## **BID ADDENDUM NO. (1)**

7/8/2024  
Bath Central School District  
Bath Capital Project 2023-2025  
2483-053

The following Addendum items shall be considered a part of the contract documents prepared by HUNT ENGINEERS, ARCHITECTS, LAND SURVEYORS & LANDSCAPE ARCHITECT, DPC.  
Bid Document date of June 18<sup>th</sup> 2024.

**1** TR 128B - ENLARGED PLAN - REVISED  
1/4" = 1'-0"

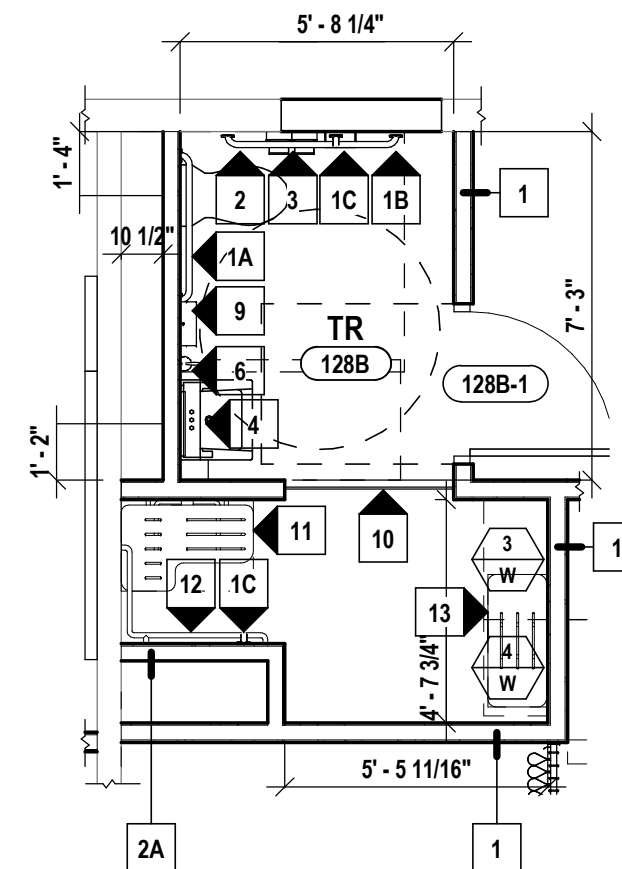
- ITEM AD1-13 Refer to HS-A5.3 – ENLARGED TOILET ROOM PLANS AND SCHEDULES**  
**AMEND** Detail 2 with detail 1 on drawing AD1-A1 – SHOWER ROOM PLAN, issued by addendum.
- ITEM AD1-14 Refer to HS-A5.3 – ENLARGED TOILET ROOM PLANS AND SCHEDULES**  
**AMEND** Detail 8 with detail 2 on drawing AD1-A1 – SHOWER ROOM PLAN, issued by addendum.

**2** SECOND FLOOR NEW WORK PLAN - PARTIAL AREA A  
1/8" = 1'-0"

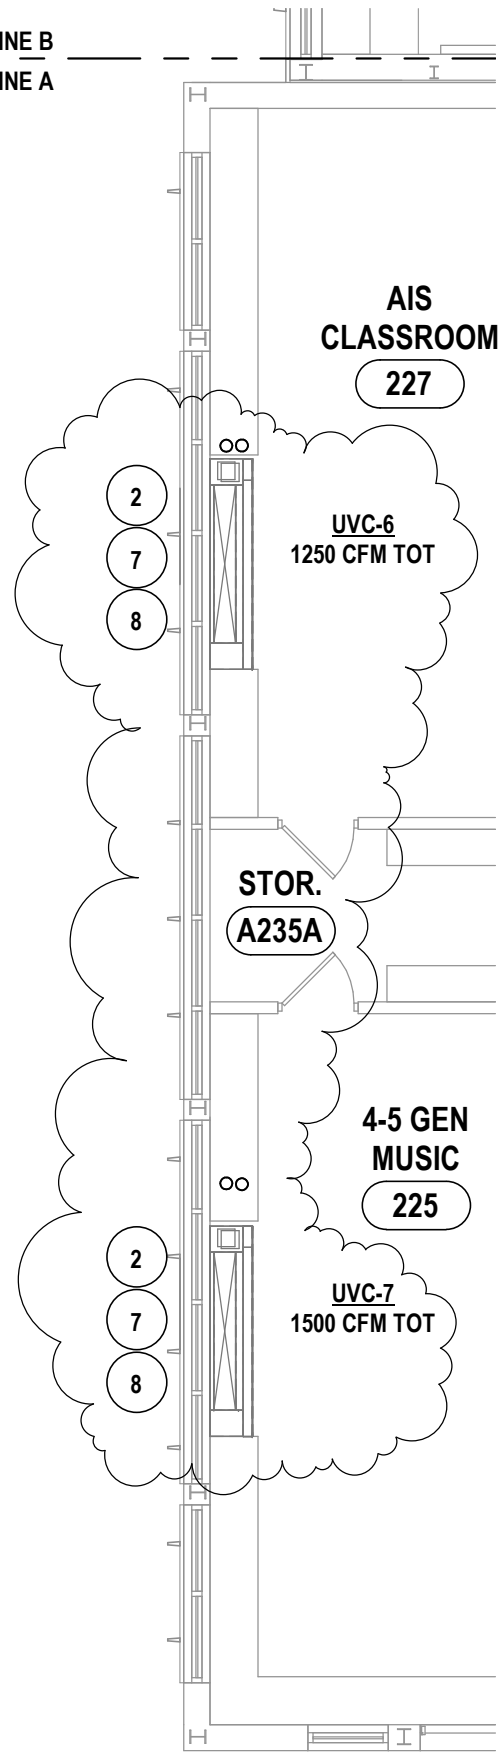
**ITEM AD1-19 Refer to HS-H1.10 – SECOND FLOOR NEW WORK PLAN – AREA A**

**ADD** Drawing Notes 2, 7, 8 to UVC-6 and UVC-7.

**1** FIRST FLOOR NEW WORK PLAN - PARTIAL AREA A PIPING MODIFICATIONS  
1/8" = 1'-0"

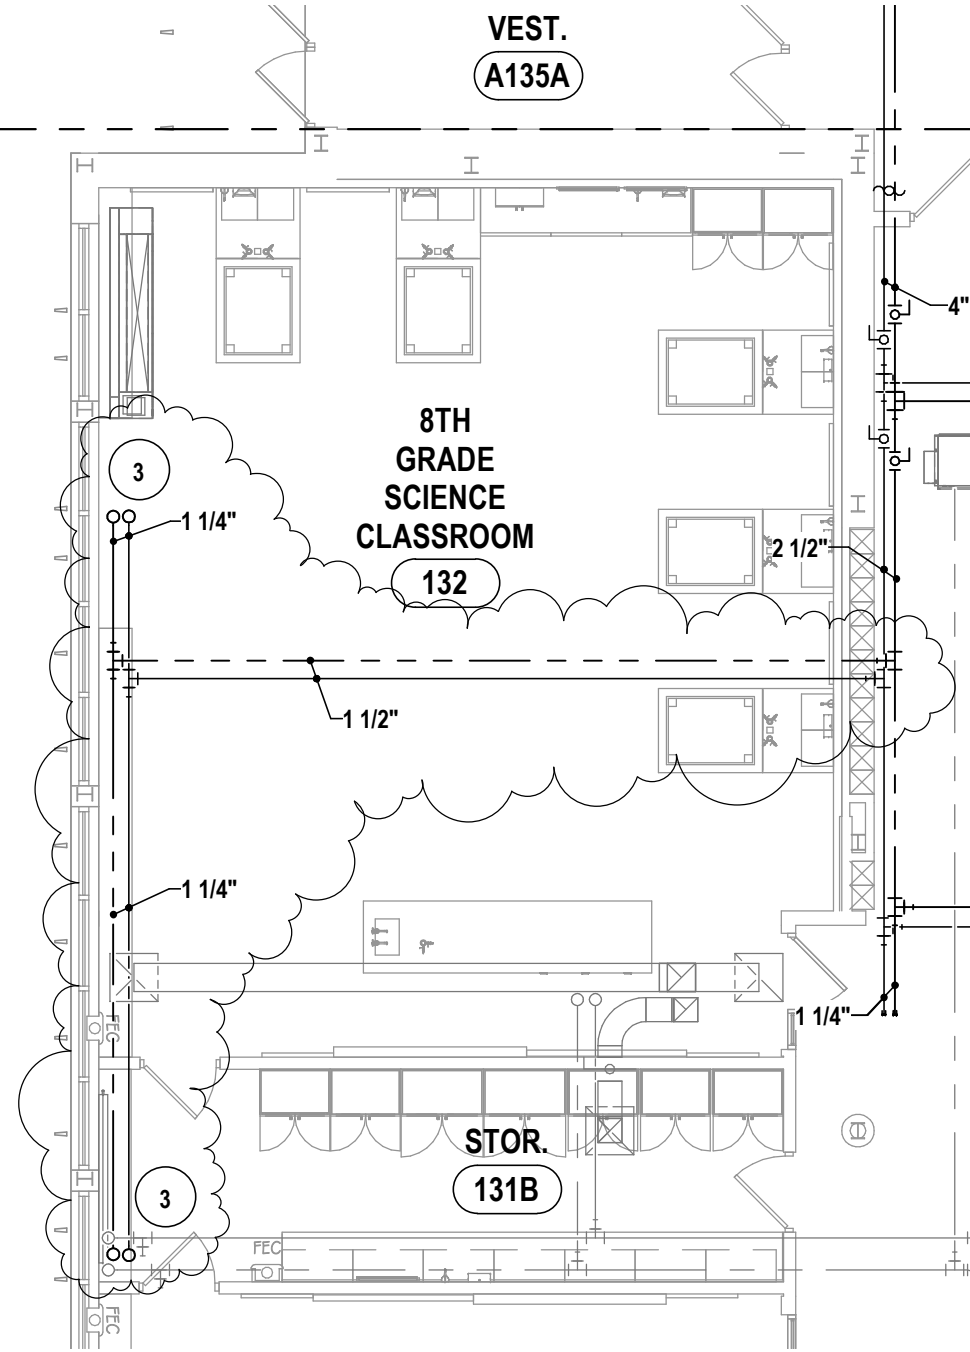
**ITEM AD1-16 Refer to HS-H1.1 – FIRST FLOOR NEW WORK PLAN – AREA A**

**AMEND** Detail 1, as indicated on drawing AD1-H1 HVAC PIPING FIRST FLOOR MODIFICATIONS AREA – A, issued by addendum.
